Mercedes-Benz in-tank modules

Replacement part solution for CLS- and E-Class

Fig. 3: Cross-section of the fuel tank (schematic)

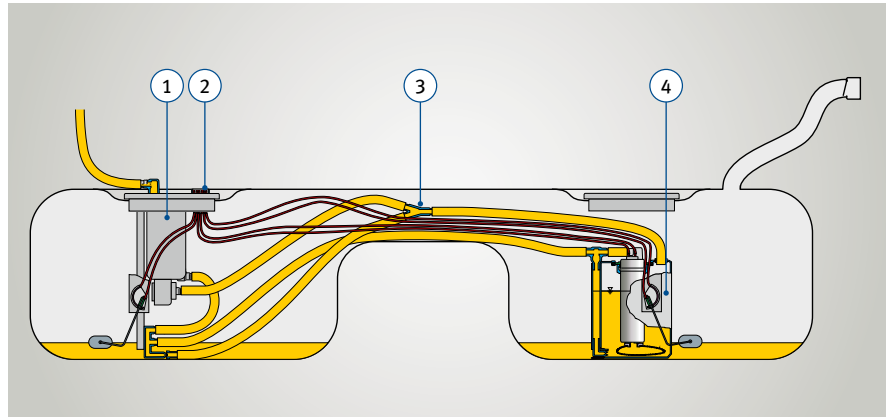
The fuel delivery module (4) is located on the right-hand side of the saddle tank when viewed in the direction of travel (F). The fuel tank sender unit (1) is located on the left-hand side of the saddle tank when viewed in the direction of travel (F).

The fuel delivery module (4) and fuel tank sender unit (1) are connected by electrical lines and fuel lines running through the narrowest point of the two sides of the tank.

The side of the fuel delivery module must also be opened for this reason when replacing the fuel tank sender unit.

The fuel delivery module (4) does not have an electrical connection in the flange cover. The power is supplied by means of the connector plug (2) on the fuel tank sender unit (1).

On the fuel tank sender unit from Motorservice, both return lines are joined into one line by a Y-connector (3).

Fig. 5: Flange cover of the fuel tank sender unit

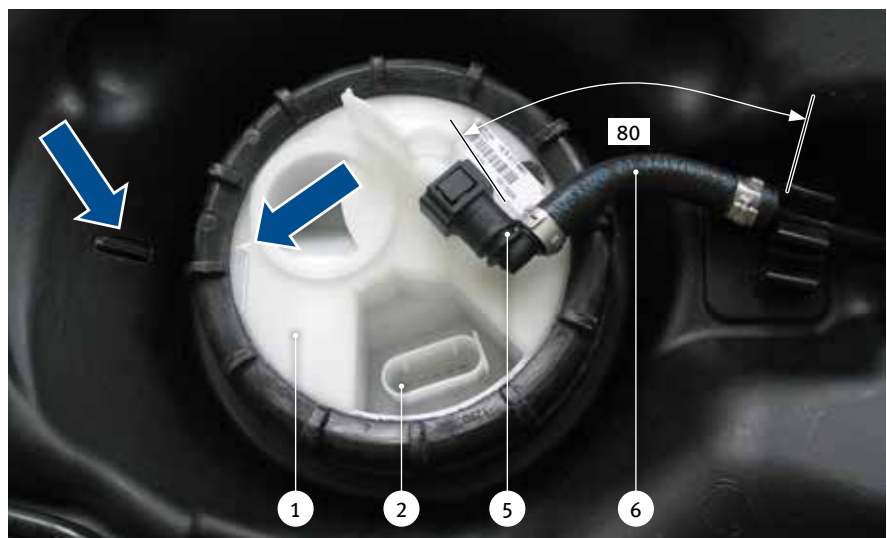
When replacing the fuel tank sender unit (1), the piece of tubing (6) of the flow line must be shorted to approx 80 mm, and the 90° quick connector (5) enclosed must be mounted (Fig. 5).

Insert the fuel delivery module and fuel tank sender unit into the fuel tank so that the arrow on the flange cover points towards the marking on the fuel tank (Fig. 5).

Fig. 9

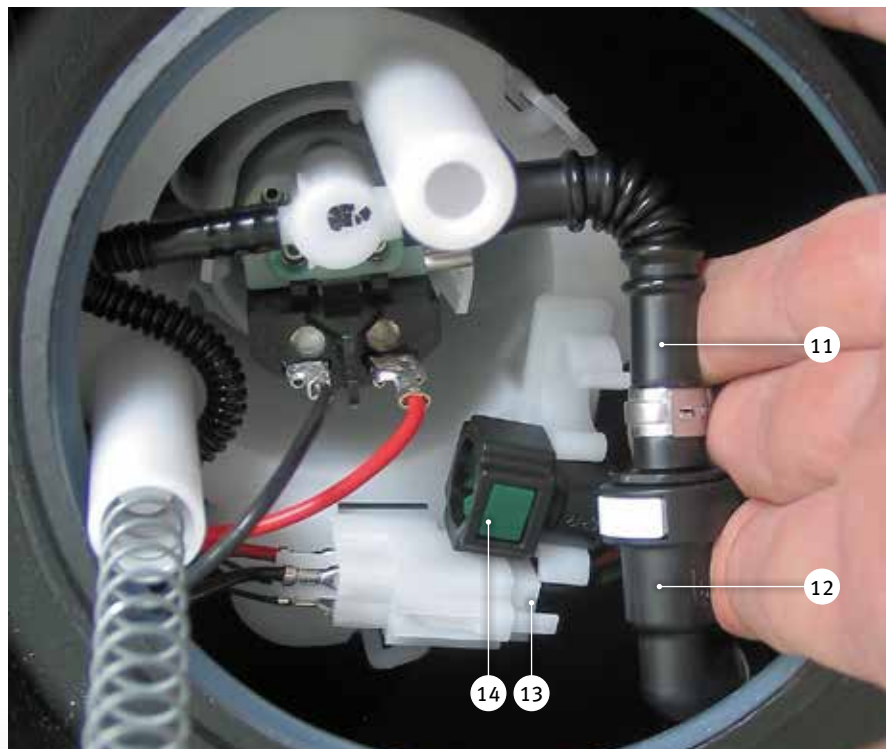
This installation position is encountered if you are replacing both the fuel delivery module and the fuel tank sender unit (Fig. 9):

- Connect pressure line to the straight piece of tubing (11) of the fuel pump with 90° quick connector (12).
- Clip 1 return line (14) into one of the two free supports on the fuel delivery module using a straight quick connector.
- Insert plug (13) of the electrical line leading to the fuel tank sender unit into the fuel delivery module.
